Contract #: 04-0120F4Cty: SF/ALA Rte: 80 PM: 13.2/13.9File #: 69.25B**QUALITY ASSURANCE -- NON-CONFORMANCE REPORT****Location:** Changxing Island, Shanghai, P.R. China**Report No:** NCR-000543**Prime Contractor:** American Bridge/Fluor Enterprises, a JV**Date:** 18-Dec-2009**Submitting Contractor:** Zhenhua Port Machinery Company, Ltd (ZPMC), Changxing Island**NCR #:** ZPMC-0516**Type of problem:**

Reference Description: Missed UT Indication by QC, Segment 8BW**Description of Non-Conformance:**

Job Name: SAS Superstructure

Subject: NCR No. ZPMC-0516

WELD NUMBER: SEG045A-001

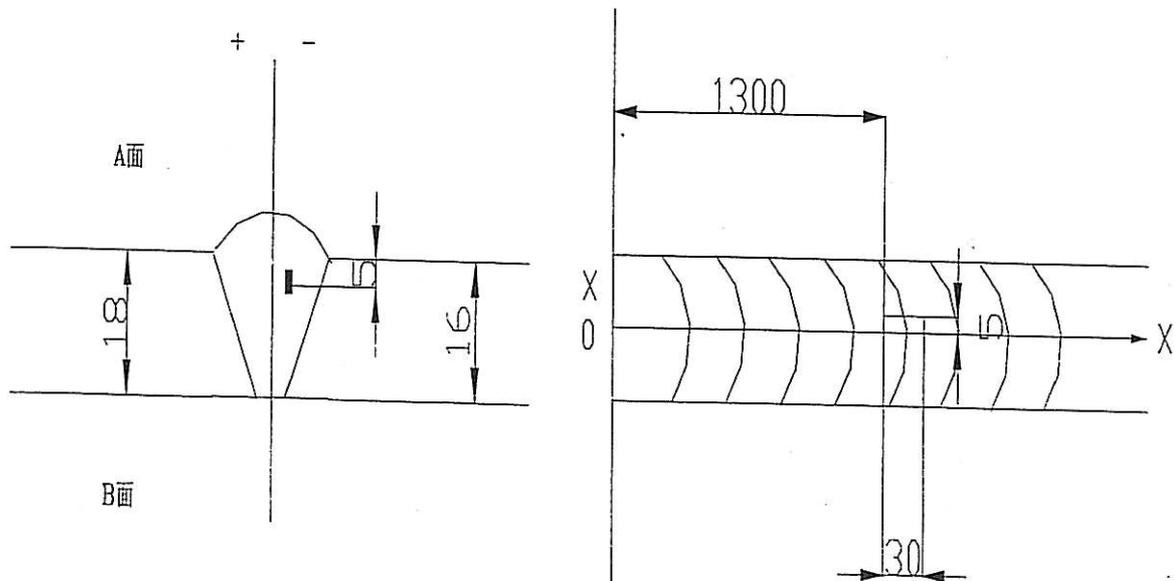
Rejected indication found by ultrasonic inspection is less than the maximum allowance aggregate length.

(UT探伤发现的缺陷总长度小于最大允许长度。) SEG045A-001

1. 从缺陷距离端面较近一侧 ($D \leq 0.65T$, D为缺陷深度, T为板厚) 采用碳刨或打磨的方法去除焊缝缺陷;
 2. 参照返修焊接工艺规程 (WPS) 准备正确的接头型式, 预热和焊接;
 3. 焊前对修补区域进行VT检测保证缺陷完全被清除;
 4. 将修补区域打磨到与母材或邻近焊缝平齐;
 5. 根据批准的车间图纸检查焊缝.
-
1. Gouge or grind from nearer side from metal edge ($D \leq 0.65T$, "D" is depth of defects, "T" is thickness of metal) to remove all defects;
 2. Follow repair WPS for joint preparation, preheat, and weld deposit;
 3. Verify with VT no defects remain in the weld joint prior to welding;
 4. Grind the repaired area flush with base metal or the adjacent weld;
 5. Check the welds according to the working drawings.
